## ARLINGTON COUNTY, VIRGINIA

**ZOA-2022-02**  
**(Clarendon Sector Plan  
Update Implementation)**

Adopted April 23, 2022  
Effective April 23, 2022

§9.2.5. Map 1, Maximum Height Limit and Step-backs

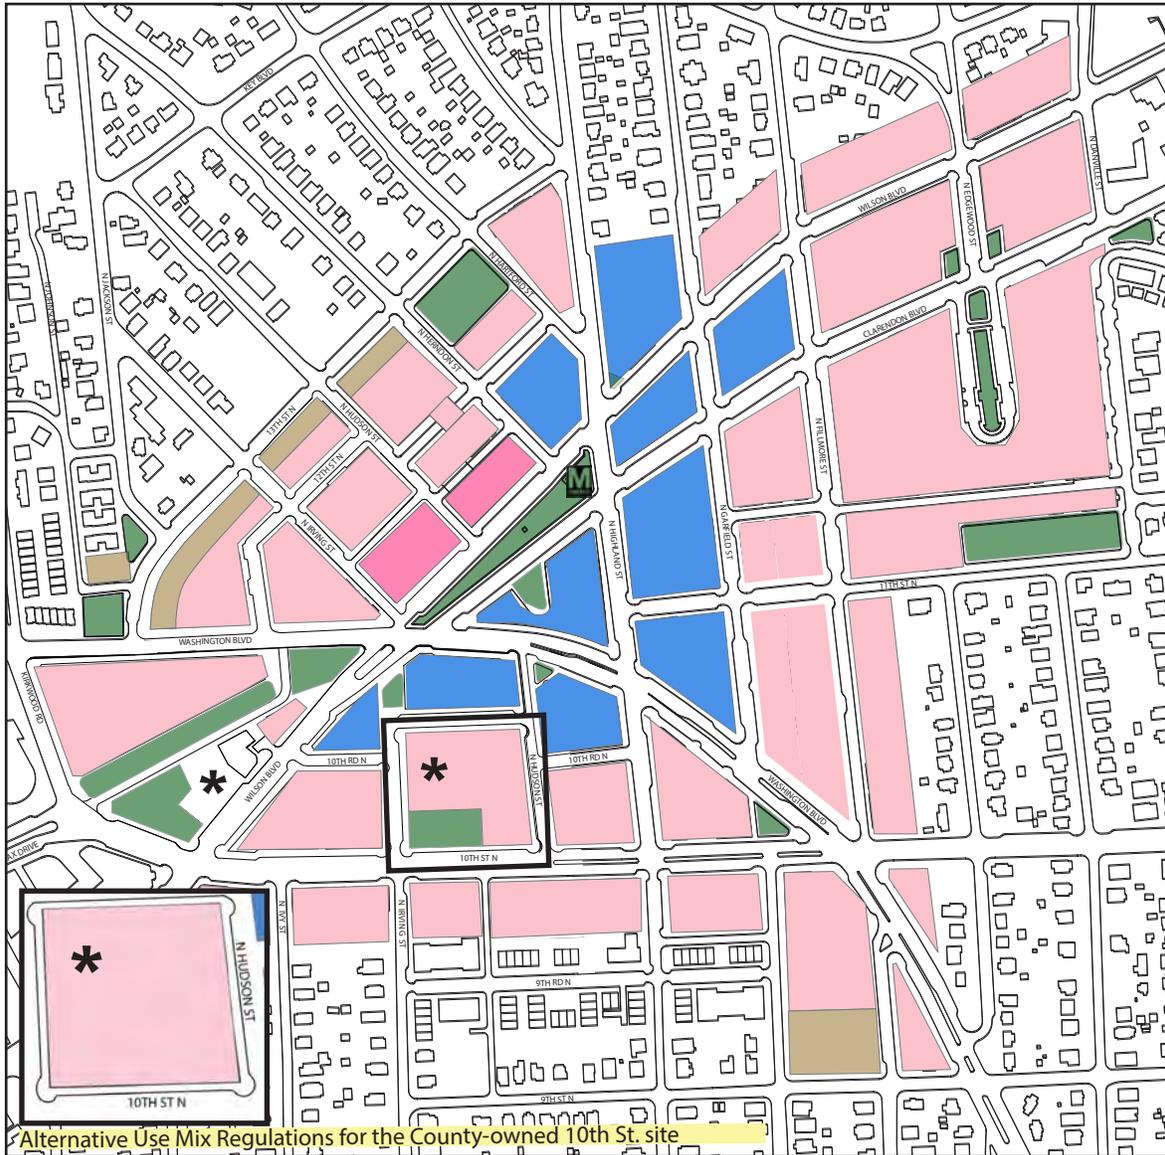
- (fg) When a building exceeds 60 feet in height, a single step-back of at least ~~20~~ **2010** feet shall be implemented beginning on the ~~second~~, third, fourth or fifth floor, on frontages designated for step-backs on the ~~Maximum Heights Limit and Step-backs Map (§9.2.5, Map 1)~~ **Step-Backs Map (§9.2.12, Map 8)**, except as provided below.

- Designated Frontages for Step-Backs when Building Heights Exceed 60 Feet - 10' Step-back at 2nd, 3rd, 4th, or 5th floors
- Designated Frontages for Step-Backs achieved through Building Facade or Building Frontage Preservation

§9.2.12. Map 8, Step-backs

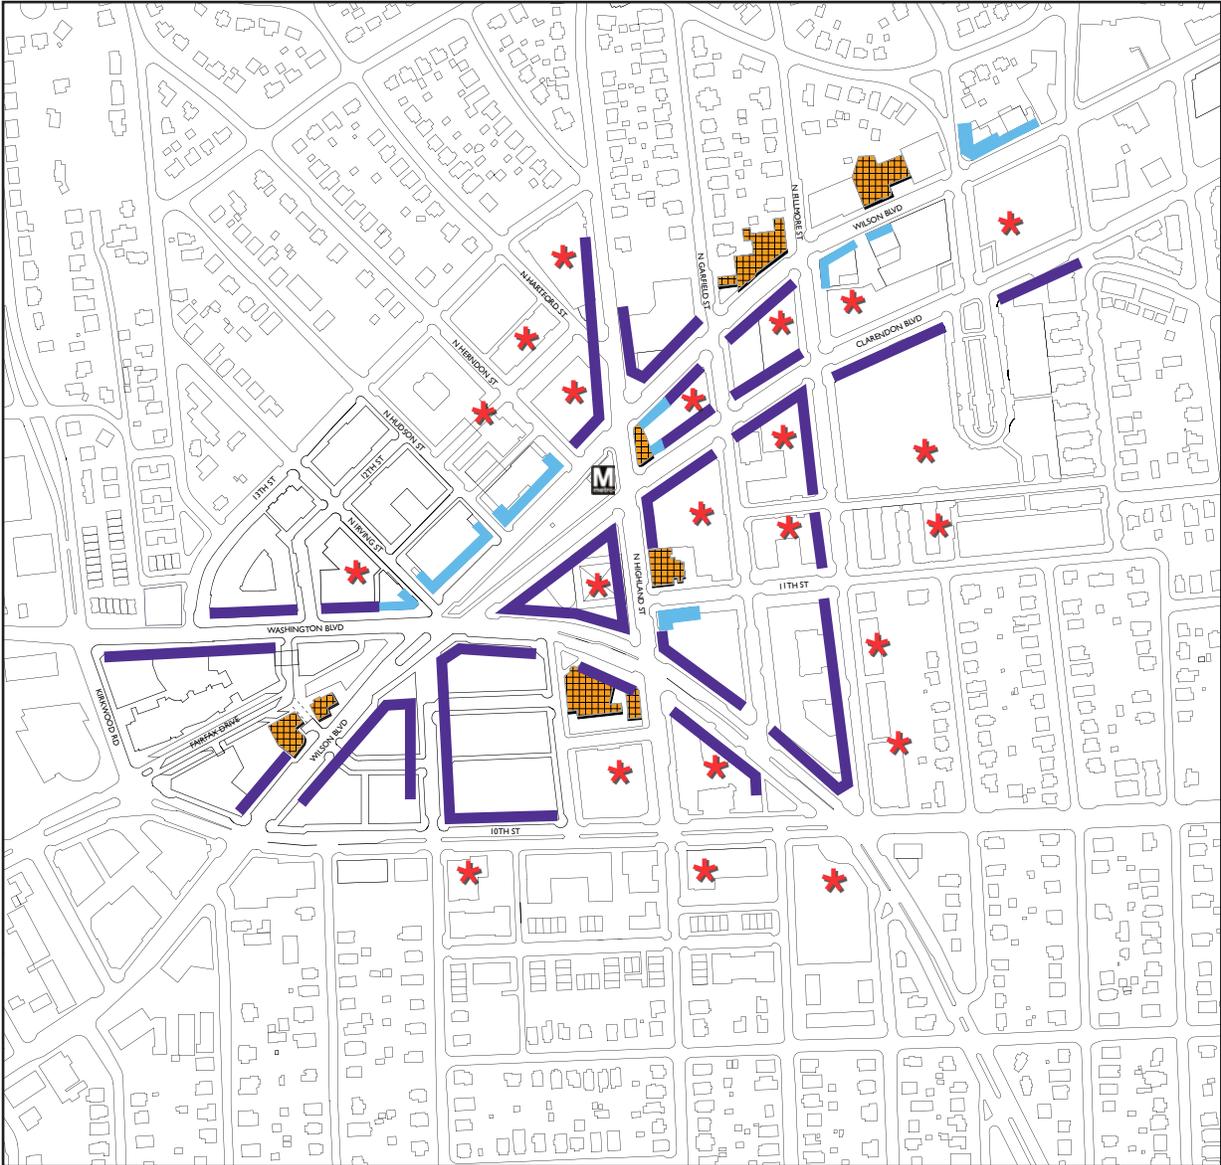
- (1) The County Board may approve modifications to the depth of the step-back on sites smaller than 20,000 square feet if the County Board determines that a ~~20~~ **2010**-foot step-back is not feasible due to the shape or configuration of the site.

Designated Frontages for Step-Backs when Building Heights Exceed 60 Feet  
 - 20' Step-back at 3rd, 4th, or 5th floors
